Model: PRIPORT LCS		Date: 7-Jan-04	No: R-C625-001c
Subject: Firmware Modification History		Prepared by: K. Yamamoto, Priport Service Planning Section	
Classification: <input type="checkbox"/> Troubleshooting <input type="checkbox"/> Part information <input type="checkbox"/> Action required <input type="checkbox"/> Mechanical <input type="checkbox"/> Electrical <input type="checkbox"/> Service manual revision <input type="checkbox"/> Paper path <input type="checkbox"/> Transmit/receive <input type="checkbox"/> Retrofit information <input checked="" type="checkbox"/> Other (Firmware release)			
Model Name: Large Capacity System LS3000

FIRMWARE MODIFICATION HISTORY

Model: PRIPORT LCS		Date: 4-Mar-04	No: R-C625-002
Subject: Undefined paper non-feed		Prepared by: K. Yamamoto, Priport Service Planning Section	
Classification: <input type="checkbox"/> Troubleshooting <input type="checkbox"/> Part information <input checked="" type="checkbox"/> Action required <input type="checkbox"/> Mechanical <input checked="" type="checkbox"/> Electrical <input type="checkbox"/> Service manual revision <input type="checkbox"/> Paper path <input type="checkbox"/> Transmit/receive <input type="checkbox

Service Manual (machine code: C625), pp. 3-21, 3-22

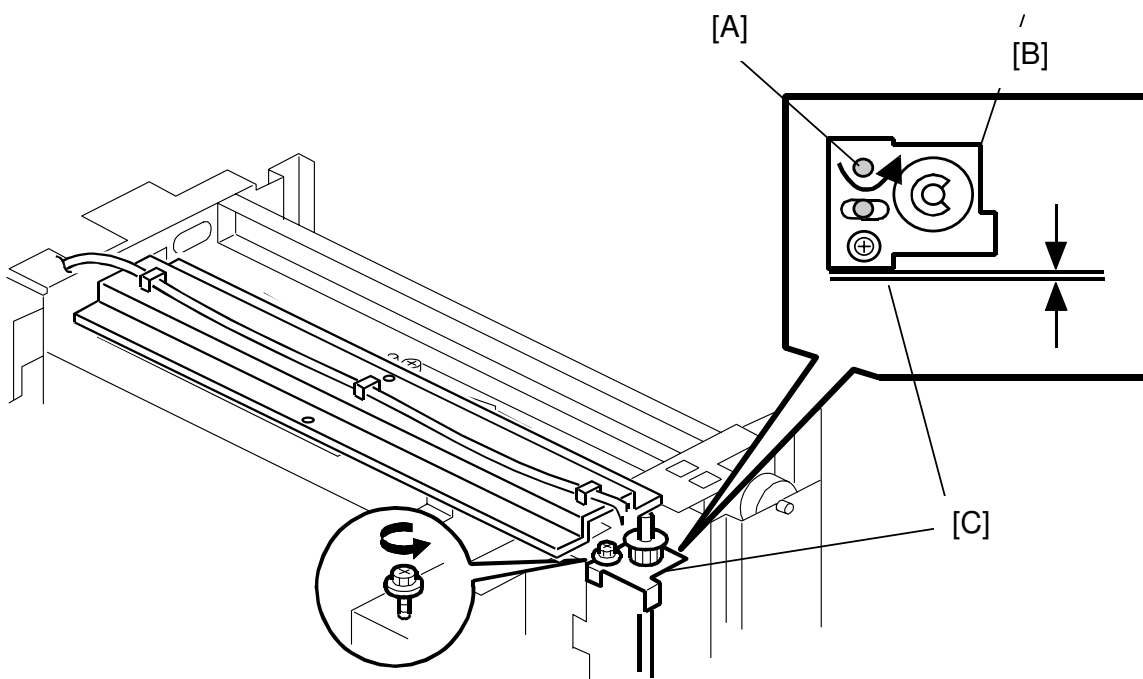
Before revision:

Note: 1) Adjust the belt tension with bracket [E]. The gap [F] must be more than 1.5 mm.

After revision:

Note: The top opening [A] in the bracket [B] is used as a pivot point to rotate the bracket and adjust the tension of the side fence belt. The bracket should be aligned parallel with the side fence [C], which will ensure the proper belt tension.

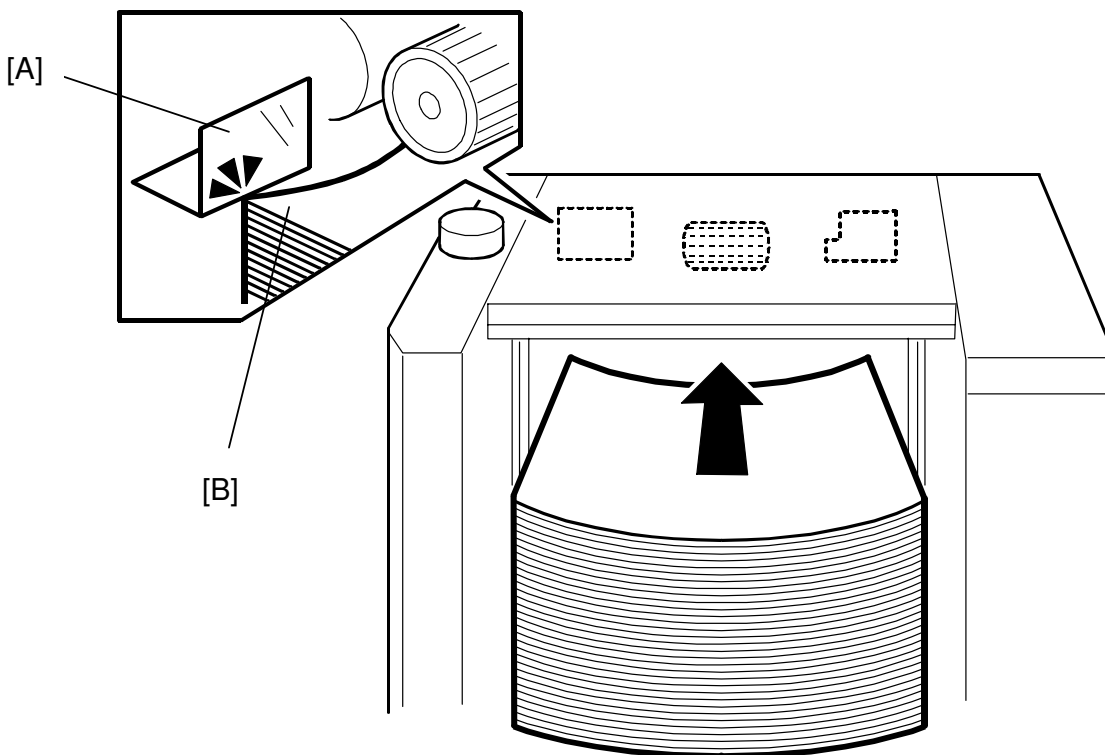
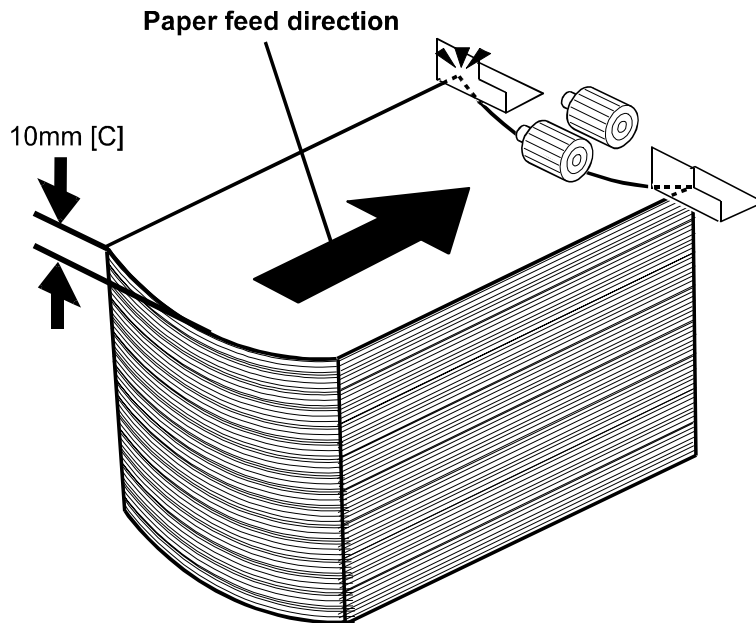
An A-jam occurs at the paper feed section if the paper is stacked near capacity (approximately 3,000 sheets) and the sheets are curled.

The paper [B] contacts the guide board sheet [A] due to the height of the stack and the curl in the paper, and the paper is fed skewed. (This curl is exaggerated with increased paper stack height).

- The curl in each individual sheet is amplified as the height of the stack increases.
- With close to 3,000 sheets, a sheet gap of about 10 mm [C] can result, which tends to trigger the skewed feed and paper jam.

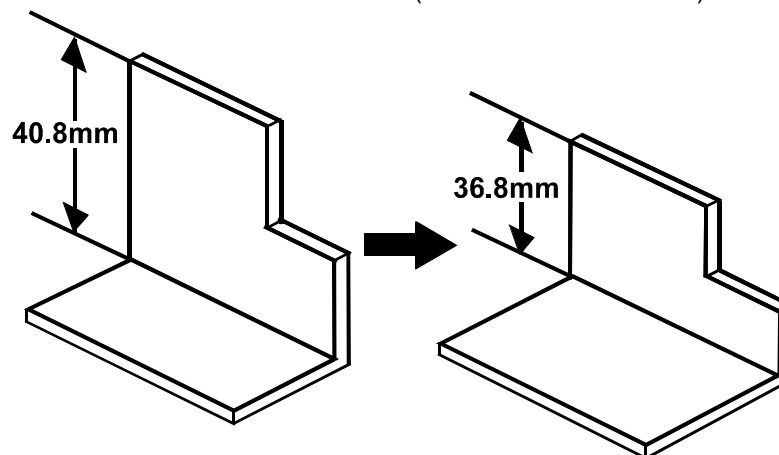
The shape of the guide board sheet has been changed to improve paper feed even when the sheets are already curled and are stacked near paper feed table capacity.

Please advise customers to use paper that is not curled, as described in the Operator's Instructions. To offset the effect from curling, it is often effective to load the paper upside down in the tray and/or fan the paper before loading.

- This modification ensures proper paper feed even when the sheet gap [C] is higher than 10mm (i.e. up to approximately 15mm).
- New guide board sheet P/N: C6252921 (see MB #MC625006).

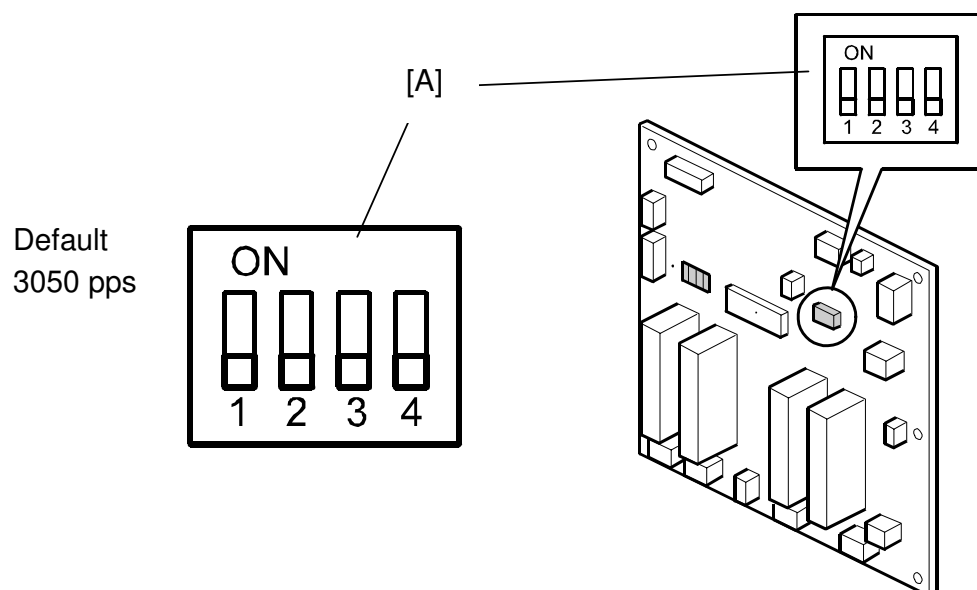
- It is possible to change the paper pickup speed in the intermediate feed section with the MPU dip switch.
 - **Note:** This change was made to ensure that the paper arrives at the duplicator feed rollers faster, which prevents A-jams.

If A-jams are reported from the field, increase the paper pickup speed with the dip switch on the MPU board.

1. Turn off the main switch, and then disconnect the power plug.
2. Remove the rear cover.
3. Set the dip switch [A] on the LCIT MPU as follows.

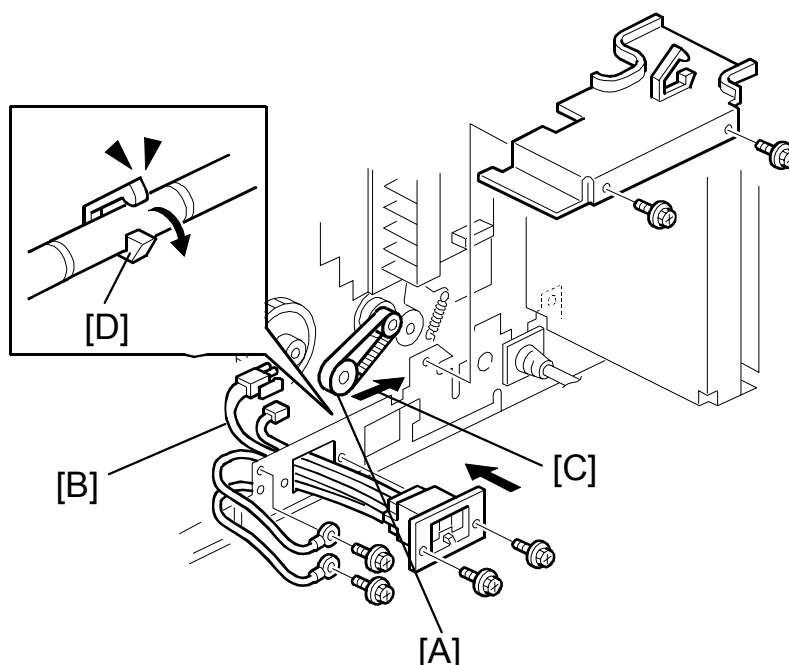
The harness [B] might touch the belt and gear [A] when you install the LCOT socket in the Emerald.

The harness [A] does not have any tension.

Pull the harness [B] in the direction of the arrow [C] until there is no slack in the harness.

A clamber [D] is added on the bottom plate, and the harness is bundled by the clamber [D].

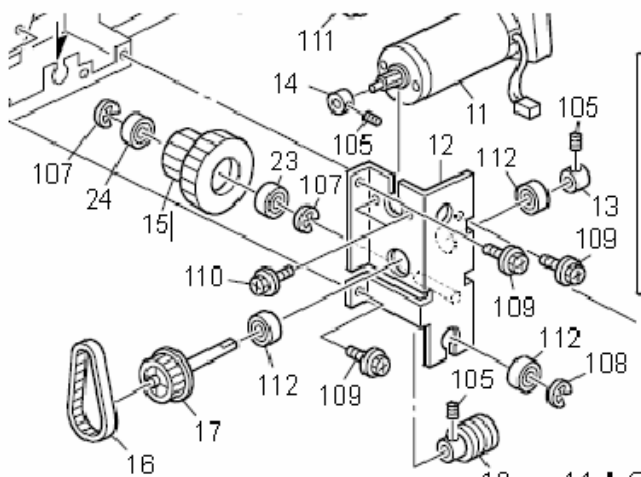
Change/Reason: The part number in the catalog was incorrect.

Correct: C5633344
Wrong: C5633350
